# Service Bulletin

Bulletin No.: 20-NA-048

**Subject:** Rattle Noise from Driver or Passenger Seat Belt

5424999

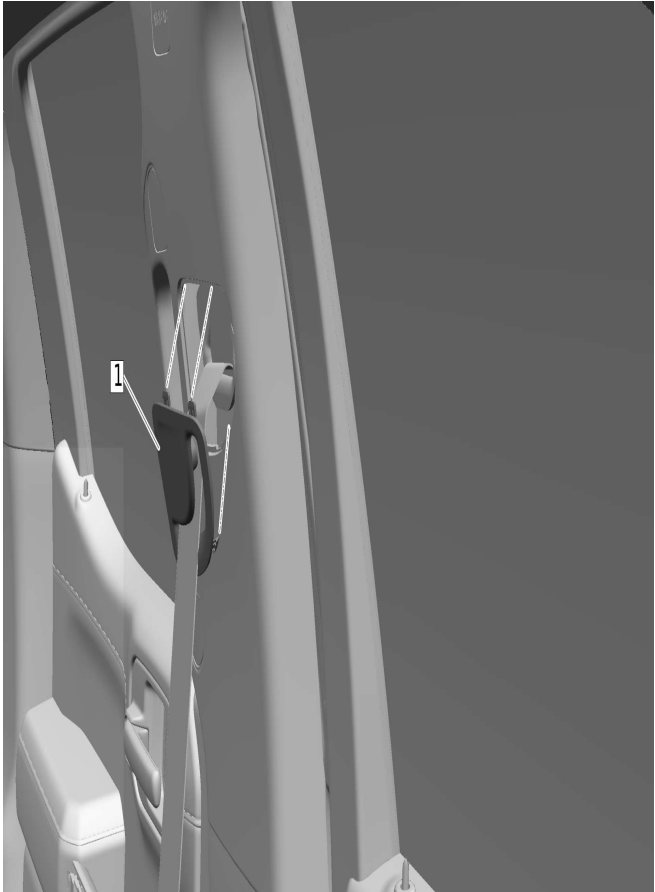
<b>Involved Region or Country</b>	North America, Europe, Russia, Middle East, Israel, Palestine, South America, Philippines, Australia, New Zealand, Egypt, Africa, South Africa
<b>Additional Options (RPOs)</b>	
<b>Condition</b>	Some customers may comment on hearing a rattle noise coming from the driver or passenger seat belt.
<b>Cause</b>	The cause of the condition may be too much clearance between the bezel and trim panel, which may allow a rattle noise generation.

**Note:** DO NOT replace the seat belt retractor for this issue, as the seat belt opening bezel has now been released as a service part.

Upon verifying the condition, replace both front seat belt opening bezels (1), 2 per vehicle. Refer to *Front Seat Belt Opening Bezel Replacement (Front Belt)*, in SI.
